**SUBJECT: NEW VEHICLE DEMONSTRATION / DELIVERY HOLD
Safety Recall 20S13
Certain 2021 Model Year Econoline
Wire Harness Frame Rail Chafe**

CERTAIN 2021 MODEL YEAR E-SERIES VEHICLES — WIRE HARNESS CHAFE

FIGURE 2

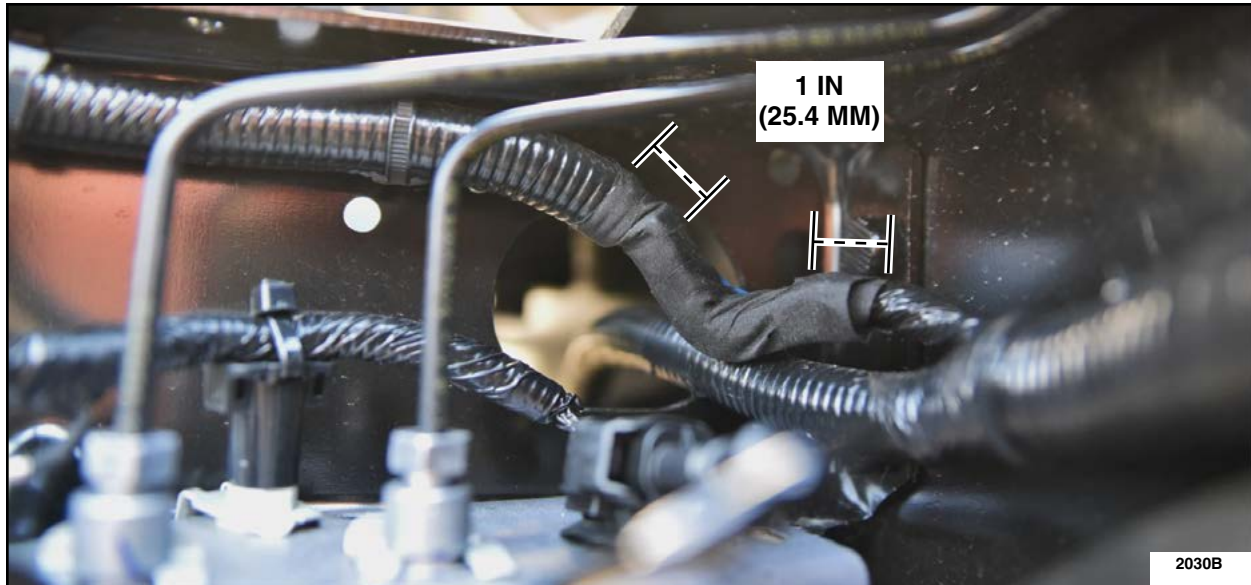
3. Add Rotunda Engineered Wire Harness Tape (NAI837X) to the elbow. Begin wrapping the tape on the convolute, one inch from the end. Continue wrapping the tape over the harness elbow using a 50% tape overlap until reaching one inch past the end of the right-angle harness routing elbow. See Figure 2.
